Supporting Planning Statement

NMA: Removal of metal louvre panels to ground floor external windows and minor alterations to fenestration

Re: Land North of Littlehampton Academy, Fitzalan Road, Littlehampton

Figure 2: Typical front elevation

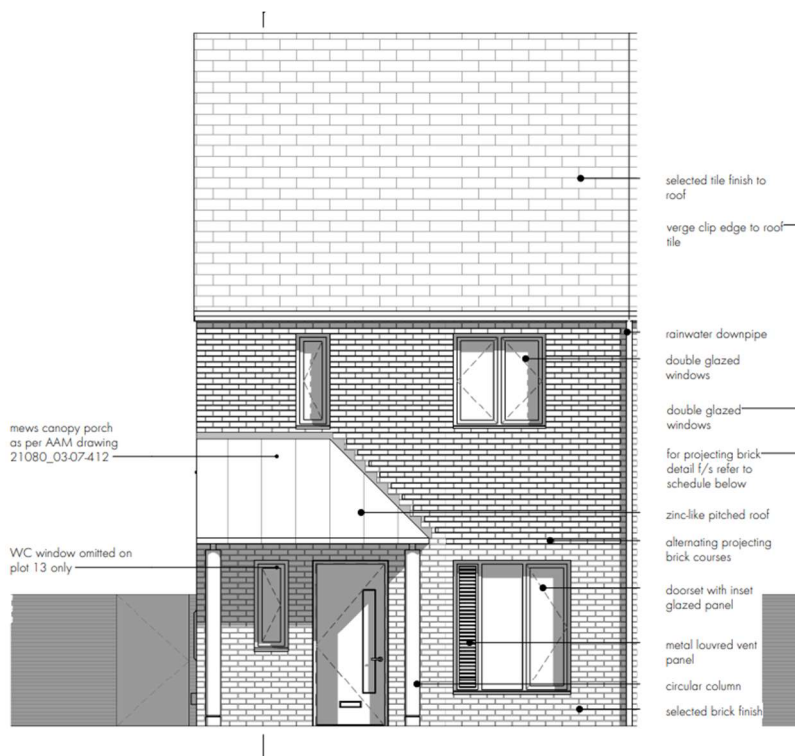
9. The planning approved house types incorporate “metal louvre vent panels” to the front elevations on the windows to the Living rooms. See figure 2 below.
10. Louvre panels are also indicated on the rear elevations to the 4B6P semi-detached type and the 2B4P semi-detached (eaves fronted) type.

11. The proposals include the removal of all the metal louvre vent panels from the elevations and the minor alterations to the fenestration to observe opening casement size limitations and to maximise the benefit of natural daylighting to individual rooms.

15. Discussions with the window supplier and wider supply chain has also revealed that options for integrated louvre panels are limited to profiled u-PVC panels glazed into the frame (in lieu of glazing). These panels have a solid flat backing internally which, is felt does not have any aesthetic appeal and would substantially reduce the level of natural daylighting and obstruct the occupants views out.

16. Independent louvres applied externally over the window would have a negative impact on the operation of the casement behind and the cleaning and maintenance of the glazing and frames which, is required to maintain product guarantees.

17. The width of the single casement windows has been increased to account for the frame profile width and to maximise the benefit of natural daylighting internally. The increase in opening width to a WC, bathroom or en-suite window also provides a greater level of purge ventilation and greater control over the internal climate thus contributing to the occupant's comfort.
